DEPARTMENT OF ECOLOGY

Re: Water Quality Certification for U.S. Army Corps of Engineers Public Notice 1996-4-02325: Construction of a Third Runway and related projects at the Seattle-Tacoma International Airport (STIA) in the Miller, Walker, and Des Moines Creek watersheds and in wetlands at the Seattle-Tacoma International Airport, located within the vicinity of the city of SeaTac, King County, Washington; and in wetlands at the mitigation site in Auburn, King County, Washington.

**IN THE MATTER OF GRANTING A  
WATER QUALITY CERTIFICATION  
AND SHORT-TERM WATER  
QUALITY MODIFICATION TO:**

**Attachment B: NRMP Plan Set Revisions**

## Borrow Area 3 Wetland and Swale Buffer

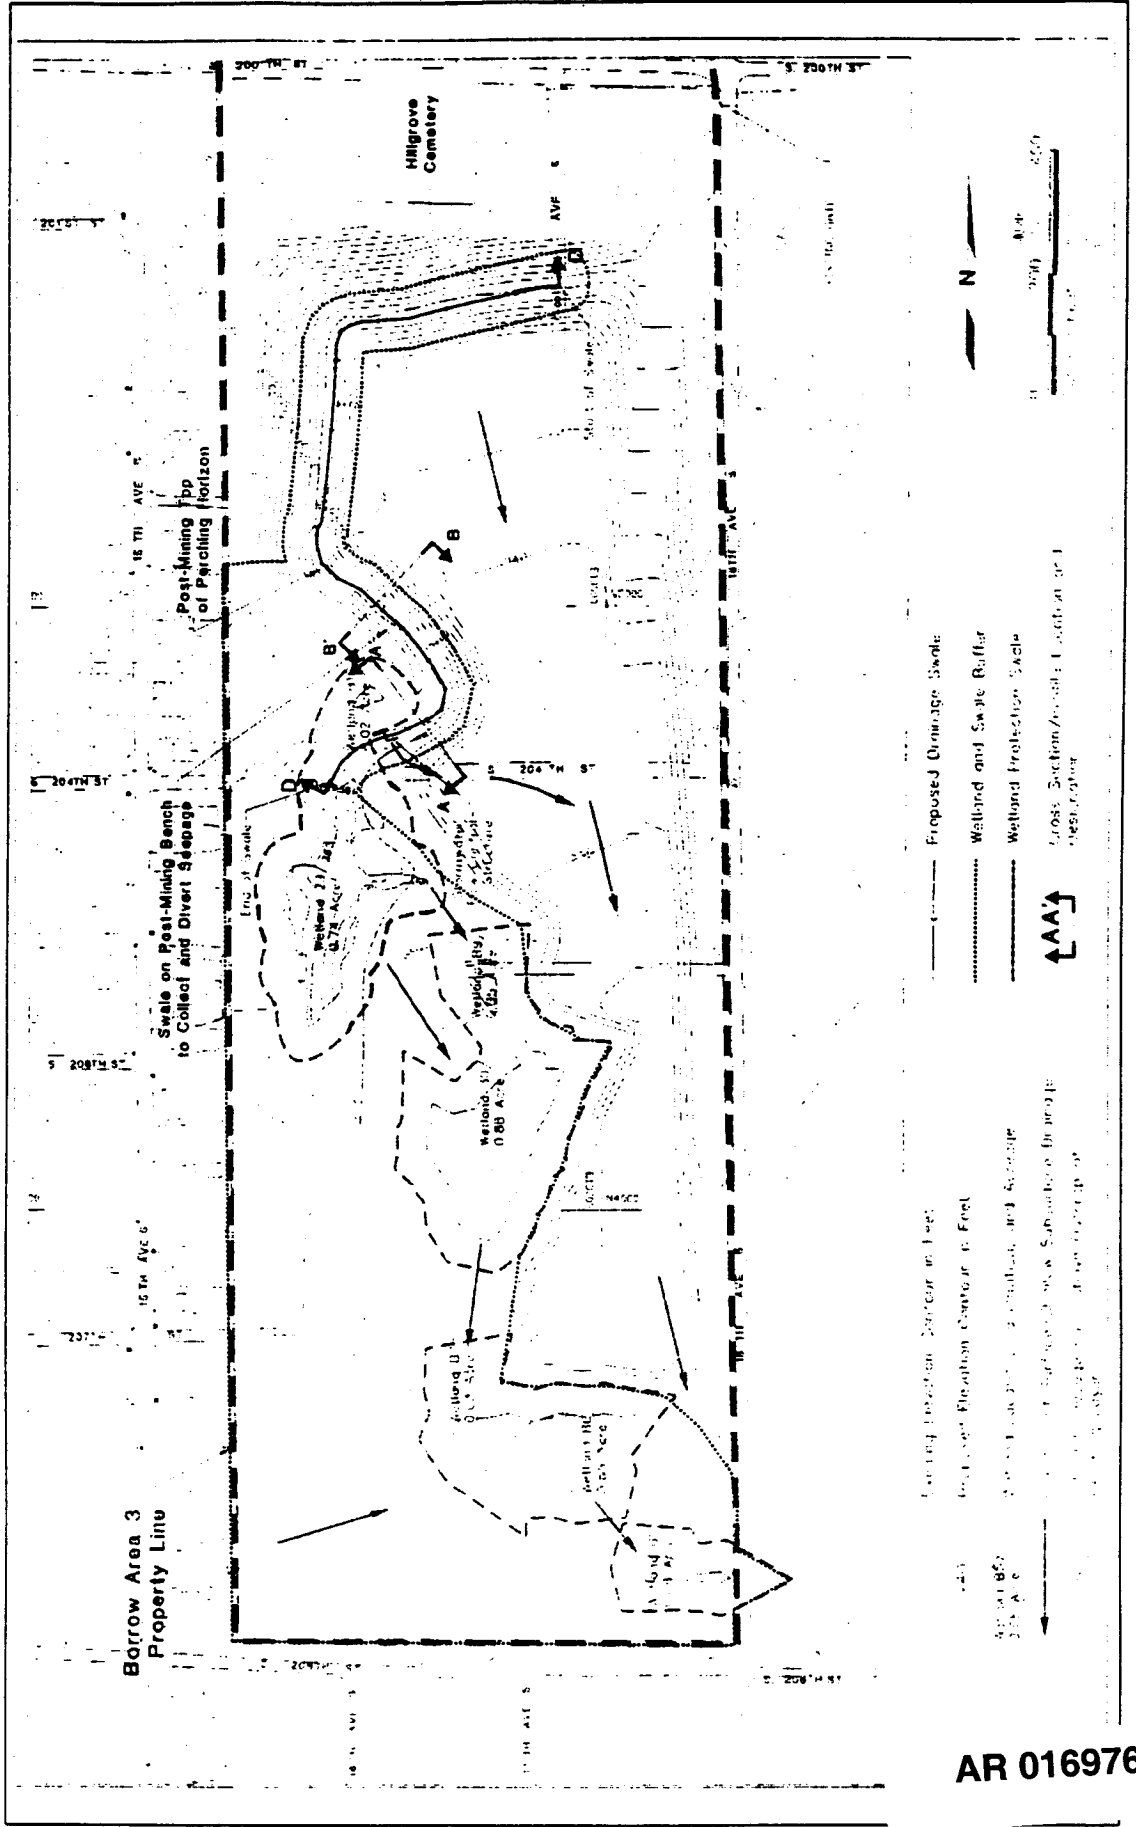
- a) The site plan from Hart Crowser titled Post Reclamation Topographic detail Borrow Area 3 Wetland Protection Swale HNTB revision (June 15, 2001 Draft) shows a flow dispersal trench overlapping with a small portion of Wetland 29. The flow dispersal trench shall not be constructed so that it is in the wetland.
